Subject: Byron Station Units 1 and 2
Braidwood Station Units 1 and 2
Advance FSAR Information
NRC Docket Nos. 50-454/455/456/457

This is to provide advance copies of information which will be included in the Byron/Braidwood FSAR in the next amendment. Attachment A to this letter lists the information enclosed.

ADVANCE FSAR INFORMATION

Figure Q22.58-1 CONCENTRATION OF COMBUSTIBLES AS A FUNCTION OF TIME WITH AND WITHOUT OPERATION OF THE COMBUSTIBLE GAS CONTROL SYSTEM

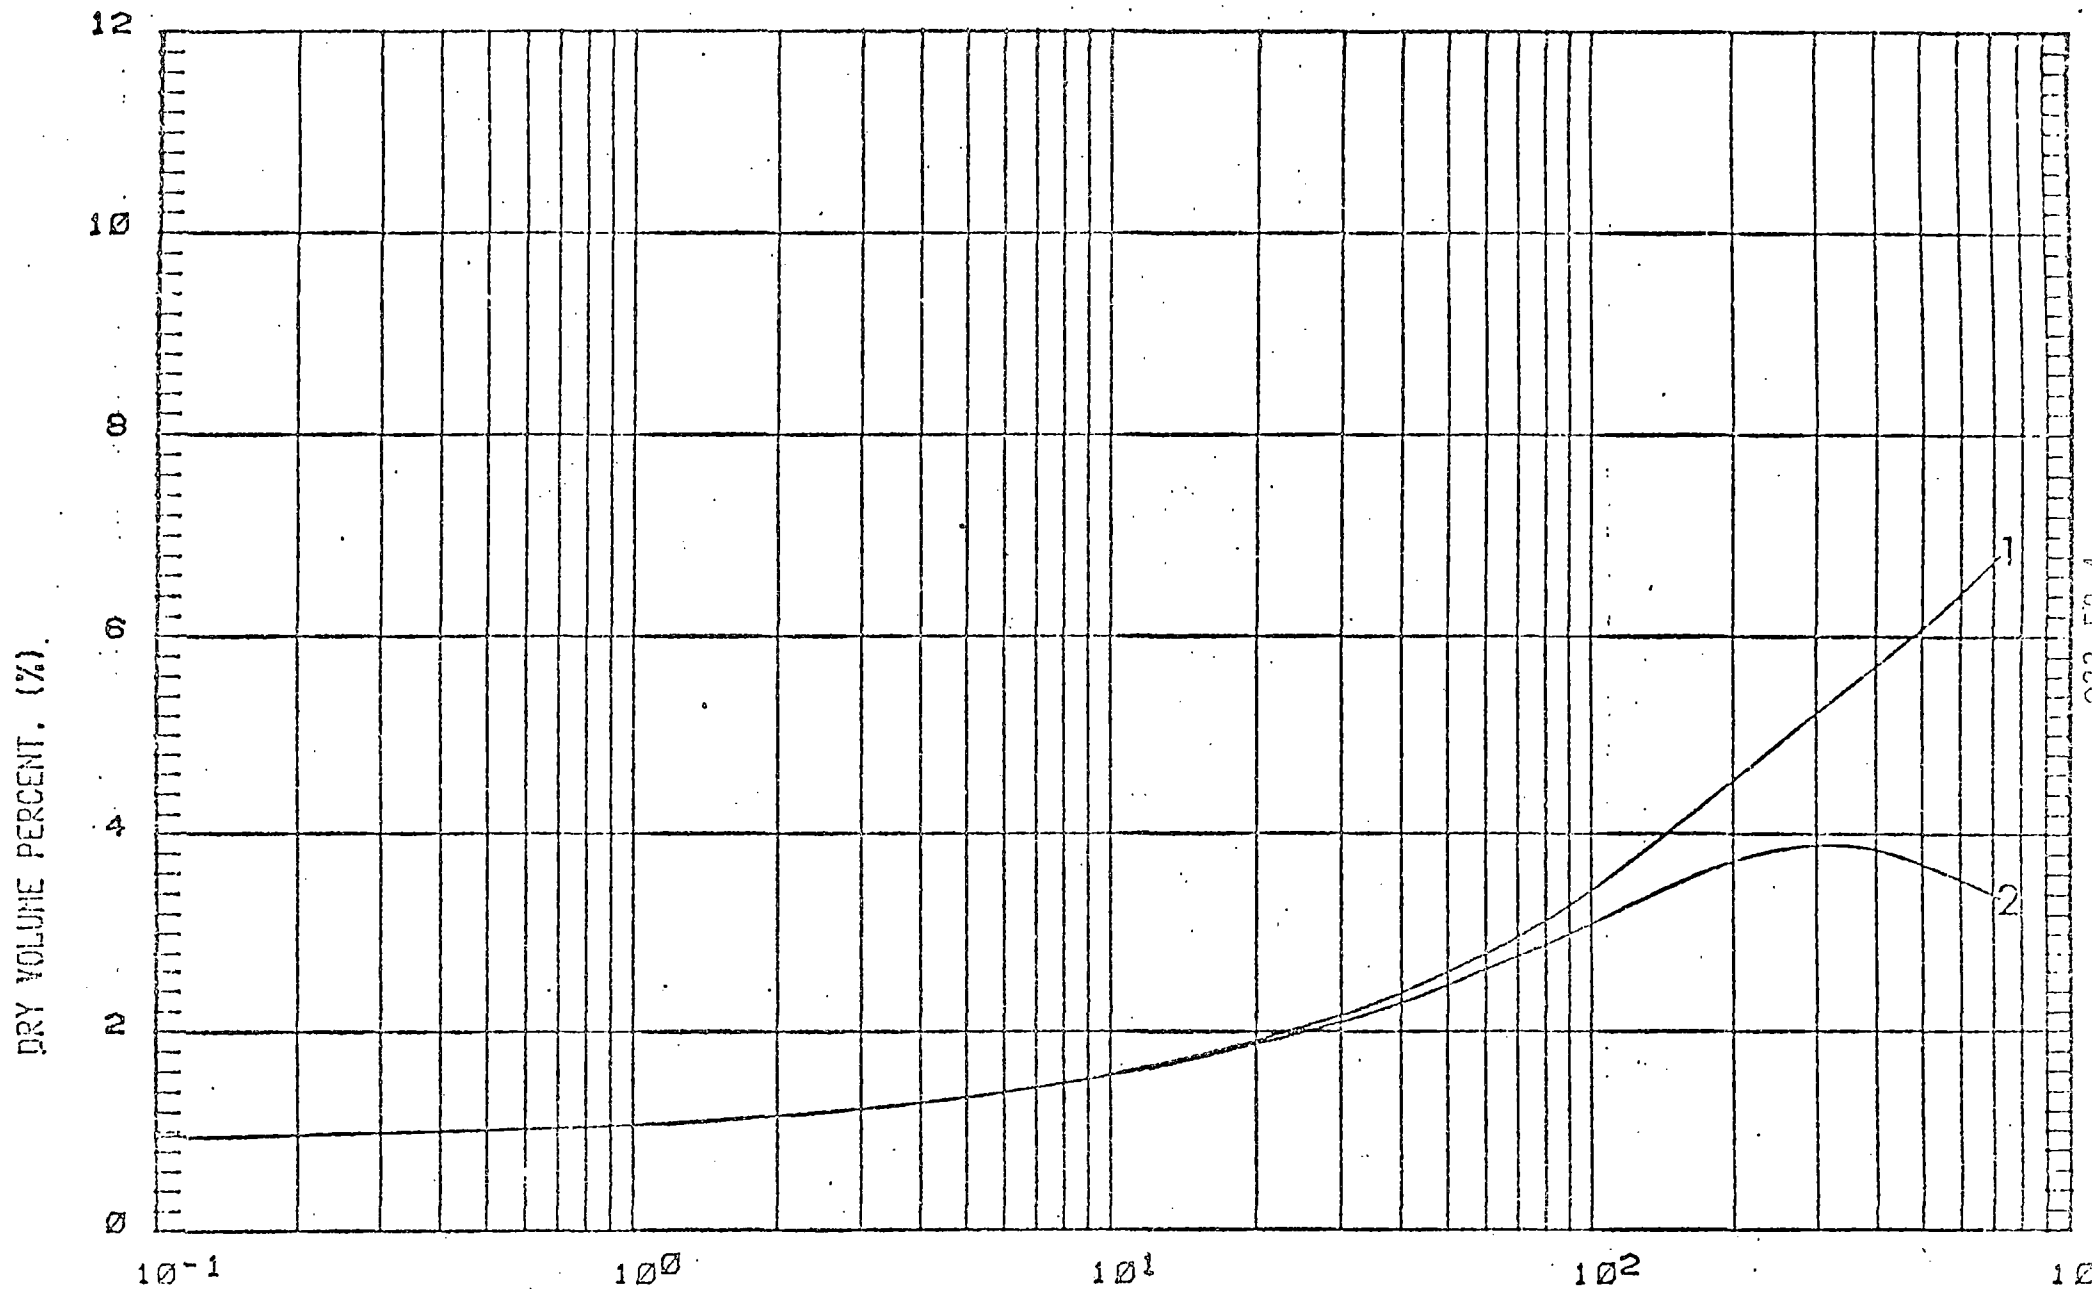
- c. The current hydrogen generation analysis assumes that the recombiner is started four hours after LOCA. This will result in a peak hydrogen concentration below 4.0%. As can be seen in Figure Q022.58-1, the recombiner has very little effect before about 10 hours due to the low hydrogen content prior to this time. Peak hydrogen

- a. The hydrogen recombiner analysis has been updated to include the current 70 cfm recombiner. This will be incorporated into the FSAR. The analysis assumes that the recombiner begins operation within 4 hours of a LOCA. Only the limiting case of a single recombiner has been analyzed. The attached figure (Figure Q022.58-1) shows the results with and without the recombiner for the limiting case.

level is relatively insensitive to the recombiner initiation time. As demonstrated by the procedural outline in item (b), operation of the recombiners requires only valve and switch operation. No difficulty is anticipated in initiating hydrogen recombination within the four hours.
